Fully Tunable Strong Spin-Orbit Interactions in Light Hole Germanium Quantum Channels

Corresponding Author: Dr Patrick Del Vecchio

This file contains all reviewer reports in order by version, followed by all author rebuttals in order by version.

FIG. 1: Longitudinal component of the z operator. $l_x = l_y = 40$ nm, $\mathbf{B} = (0.05 \text{ T})\mathbf{e}_y$.

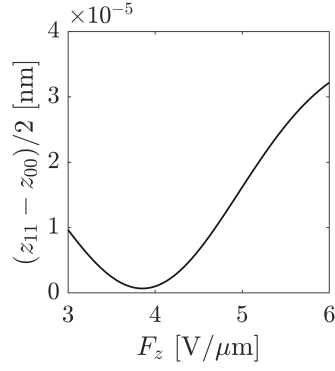
3. *In particular, while the robustness of the β -line is tested against θ , l_x , and l_y , sensitivity to electric field fluctuations is not discussed. In fact, the results presented in Fig. 3 suggest that the β -line is very steep in the F_z direction, which would make it highly sensitive to charge noise. The authors should comment on this point. Note that this implies an "off-state" with zero spin-orbit interaction is not necessarily a low-decoherence state if the noise sensitivity is high.*

We agree that the Rabi frequency graphs indicate a steep derivative with respect to the gate field. However we emphasize that it is not necessarily an indication of a higher sensitivity to charge noise. The dephasing rate of the qubit is mostly sensitive to longitudinal noise in the qubit subspace, or components of the noise that change the Larmor frequency. Regarding this, Fig. 2c and 2e suggest that close to the zero-SOI operation point ($F_z \approx 4.4 \text{ V}/\mu\text{m}$), the in-plane and out-of-plane components of the g -factor have very small slopes with respect to F_z and thus we do not expect a significant increase in charge noise sensitivity. In fact, the longitudinal component of the z operator, $|\langle 1|z|1\rangle - \langle 0|z|0\rangle|/2$, shows a minimum with respect to F_z near the zero-SOI operation point (see Fig. 1 below. We added a sentence in the main text just before the conclusion to address this point.)

FIG. 2: Longitudinal component of the z operator. $l_x = l_y = 40 \text{ nm}$, $\mathbf{B} = (0.05 \text{ T})\mathbf{e}_y$.

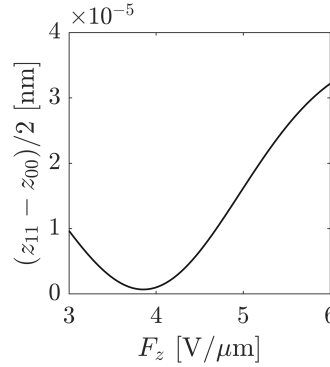
4. In Fig. 3(b, c), the SOI-off points show large $\partial\Omega/\partial F_z$, indicating strong sensitivity to charge noise. Given the magnified charge noise in the proposed device, idling the qubit at $\Omega = 0$ under these conditions may negate the intended benefit of turning off the SOI. A quantitative or qualitative discussion of charge noise and its impact on qubit performance at the SOI-off point is required.

We agree that the Rabi frequency plots indicate a steep incline with respect to the gate field. However it is not necessarily an indication of a higher sensitivity to charge noise. The dephasing rate of the qubit is mostly sensitive to longitudinal noise in the qubit subspace, or components of the noise that change the Larmor frequency. Regarding this, Fig. 2c and 2e suggest that close to the zero-SOI operation point ($F_z \approx 4.4 \text{ V}/\mu\text{m}$), the in-plane and out-of-plane components of the g -factor have very small inclines with respect to F_z and thus we do not expect a significant increase in charge noise sensitivity. In fact, the longitudinal component of the z operator, $|\langle 1|z|1\rangle - \langle 0|z|0\rangle|/2$, shows a minimum with respect to F_z near the zero-SOI operation point (see the figure just below). We added a sentence in the main text in the paragraph just before the conclusion to clarify this point.

FIG. 1: Longitudinal component of the z operator. $l_x = l_y = 40$ nm, $\mathbf{B} = (0.05 \text{ T})\mathbf{e}_y$.

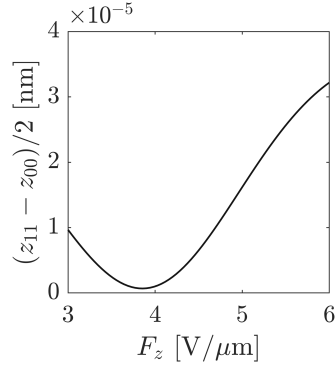
3. *In particular, while the robustness of the β -line is tested against θ , l_x , and l_y , sensitivity to electric field fluctuations is not discussed. In fact, the results presented in Fig. 3 suggest that the β -line is very steep in the F_z direction, which would make it highly sensitive to charge noise. The authors should comment on this point. Note that this implies an "off-state" with zero spin-orbit interaction is not necessarily a low-decoherence state if the noise sensitivity is high.*

We agree that the Rabi frequency graphs indicate a steep derivative with respect to the gate field. However we emphasize that it is not necessarily an indication of a higher sensitivity to charge noise. The dephasing rate of the qubit is mostly sensitive to longitudinal noise in the qubit subspace, or components of the noise that change the Larmor frequency. Regarding this, Fig. 2c and 2e suggest that close to the zero-SOI operation point ($F_z \approx 4.4 \text{ V}/\mu\text{m}$), the in-plane and out-of-plane components of the g -factor have very small slopes with respect to F_z and thus we do not expect a significant increase in charge noise sensitivity. In fact, the longitudinal component of the z operator, $|\langle 1|z|1\rangle - \langle 0|z|0\rangle|/2$, shows a minimum with respect to F_z near the zero-SOI operation point (see Fig. 1 below. We added a sentence in the main text just before the conclusion to address this point.)

FIG. 2: Longitudinal component of the z operator. $l_x = l_y = 40 \text{ nm}$, $\mathbf{B} = (0.05 \text{ T})\mathbf{e}_y$.

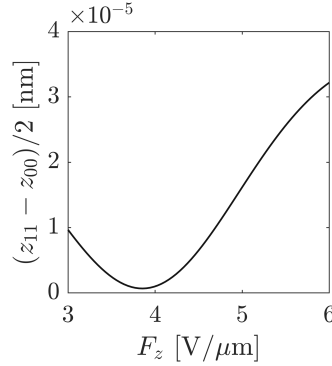
4. In Fig. 3(b, c), the SOI-off points show large $\partial\Omega/\partial F_z$, indicating strong sensitivity to charge noise. Given the magnified charge noise in the proposed device, idling the qubit at $\Omega = 0$ under these conditions may negate the intended benefit of turning off the SOI. A quantitative or qualitative discussion of charge noise and its impact on qubit performance at the SOI-off point is required.

We agree that the Rabi frequency plots indicate a steep incline with respect to the gate field. However it is not necessarily an indication of a higher sensitivity to charge noise. The dephasing rate of the qubit is mostly sensitive to longitudinal noise in the qubit subspace, or components of the noise that change the Larmor frequency. Regarding this, Fig. 2c and 2e suggest that close to the zero-SOI operation point ($F_z \approx 4.4 \text{ V}/\mu\text{m}$), the in-plane and out-of-plane components of the g -factor have very small inclines with respect to F_z and thus we do not expect a significant increase in charge noise sensitivity. In fact, the longitudinal component of the z operator, $|\langle 1|z|1\rangle - \langle 0|z|0\rangle|/2$, shows a minimum with respect to F_z near the zero-SOI operation point (see the figure just below). We added a sentence in the main text in the paragraph just before the conclusion to clarify this point.

FIG. 1: Longitudinal component of the z operator. $l_x = l_y = 40$ nm, $\mathbf{B} = (0.05 \text{ T})\mathbf{e}_y$.

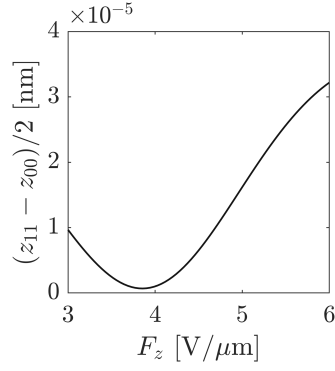
3. *In particular, while the robustness of the β -line is tested against θ , l_x , and l_y , sensitivity to electric field fluctuations is not discussed. In fact, the results presented in Fig. 3 suggest that the β -line is very steep in the F_z direction, which would make it highly sensitive to charge noise. The authors should comment on this point. Note that this implies an "off-state" with zero spin-orbit interaction is not necessarily a low-decoherence state if the noise sensitivity is high.*

We agree that the Rabi frequency graphs indicate a steep derivative with respect to the gate field. However we emphasize that it is not necessarily an indication of a higher sensitivity to charge noise. The dephasing rate of the qubit is mostly sensitive to longitudinal noise in the qubit subspace, or components of the noise that change the Larmor frequency. Regarding this, Fig. 2c and 2e suggest that close to the zero-SOI operation point ($F_z \approx 4.4 \text{ V}/\mu\text{m}$), the in-plane and out-of-plane components of the g -factor have very small slopes with respect to F_z and thus we do not expect a significant increase in charge noise sensitivity. In fact, the longitudinal component of the z operator, $|\langle 1|z|1\rangle - \langle 0|z|0\rangle|/2$, shows a minimum with respect to F_z near the zero-SOI operation point (see Fig. 1 below. We added a sentence in the main text just before the conclusion to address this point.)

FIG. 2: Longitudinal component of the z operator. $l_x = l_y = 40 \text{ nm}$, $\mathbf{B} = (0.05 \text{ T})\mathbf{e}_y$.

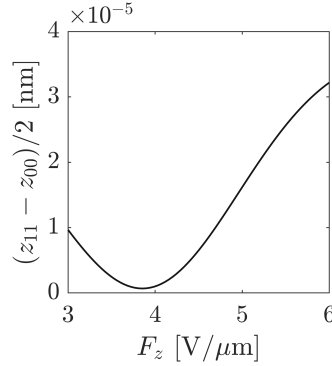
4. In Fig. 3(b, c), the SOI-off points show large $\partial\Omega/\partial F_z$, indicating strong sensitivity to charge noise. Given the magnified charge noise in the proposed device, idling the qubit at $\Omega = 0$ under these conditions may negate the intended benefit of turning off the SOI. A quantitative or qualitative discussion of charge noise and its impact on qubit performance at the SOI-off point is required.

We agree that the Rabi frequency plots indicate a steep incline with respect to the gate field. However it is not necessarily an indication of a higher sensitivity to charge noise. The dephasing rate of the qubit is mostly sensitive to longitudinal noise in the qubit subspace, or components of the noise that change the Larmor frequency. Regarding this, Fig. 2c and 2e suggest that close to the zero-SOI operation point ($F_z \approx 4.4 \text{ V}/\mu\text{m}$), the in-plane and out-of-plane components of the g -factor have very small inclines with respect to F_z and thus we do not expect a significant increase in charge noise sensitivity. In fact, the longitudinal component of the z operator, $|\langle 1|z|1\rangle - \langle 0|z|0\rangle|/2$, shows a minimum with respect to F_z near the zero-SOI operation point (see the figure just below). We added a sentence in the main text in the paragraph just before the conclusion to clarify this point.

FIG. 1: Longitudinal component of the z operator. $l_x = l_y = 40$ nm, $\mathbf{B} = (0.05 \text{ T})\mathbf{e}_y$.

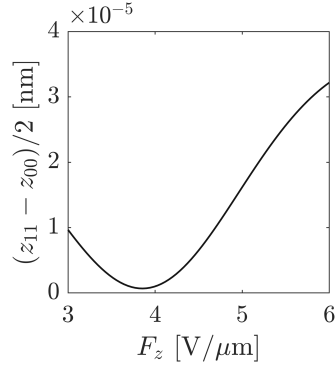
3. *In particular, while the robustness of the β -line is tested against θ , l_x , and l_y , sensitivity to electric field fluctuations is not discussed. In fact, the results presented in Fig. 3 suggest that the β -line is very steep in the F_z direction, which would make it highly sensitive to charge noise. The authors should comment on this point. Note that this implies an "off-state" with zero spin-orbit interaction is not necessarily a low-decoherence state if the noise sensitivity is high.*

We agree that the Rabi frequency graphs indicate a steep derivative with respect to the gate field. However we emphasize that it is not necessarily an indication of a higher sensitivity to charge noise. The dephasing rate of the qubit is mostly sensitive to longitudinal noise in the qubit subspace, or components of the noise that change the Larmor frequency. Regarding this, Fig. 2c and 2e suggest that close to the zero-SOI operation point ($F_z \approx 4.4 \text{ V}/\mu\text{m}$), the in-plane and out-of-plane components of the g -factor have very small slopes with respect to F_z and thus we do not expect a significant increase in charge noise sensitivity. In fact, the longitudinal component of the z operator, $|\langle 1|z|1\rangle - \langle 0|z|0\rangle|/2$, shows a minimum with respect to F_z near the zero-SOI operation point (see Fig. 1 below. We added a sentence in the main text just before the conclusion to address this point.)

FIG. 2: Longitudinal component of the z operator. $l_x = l_y = 40 \text{ nm}$, $\mathbf{B} = (0.05 \text{ T})\mathbf{e}_y$.

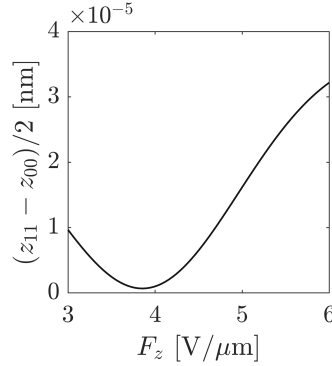
4. In Fig. 3(b, c), the SOI-off points show large $\partial\Omega/\partial F_z$, indicating strong sensitivity to charge noise. Given the magnified charge noise in the proposed device, idling the qubit at $\Omega = 0$ under these conditions may negate the intended benefit of turning off the SOI. A quantitative or qualitative discussion of charge noise and its impact on qubit performance at the SOI-off point is required.

We agree that the Rabi frequency plots indicate a steep incline with respect to the gate field. However it is not necessarily an indication of a higher sensitivity to charge noise. The dephasing rate of the qubit is mostly sensitive to longitudinal noise in the qubit subspace, or components of the noise that change the Larmor frequency. Regarding this, Fig. 2c and 2e suggest that close to the zero-SOI operation point ($F_z \approx 4.4 \text{ V}/\mu\text{m}$), the in-plane and out-of-plane components of the g -factor have very small inclines with respect to F_z and thus we do not expect a significant increase in charge noise sensitivity. In fact, the longitudinal component of the z operator, $|\langle 1|z|1\rangle - \langle 0|z|0\rangle|/2$, shows a minimum with respect to F_z near the zero-SOI operation point (see the figure just below). We added a sentence in the main text in the paragraph just before the conclusion to clarify this point.
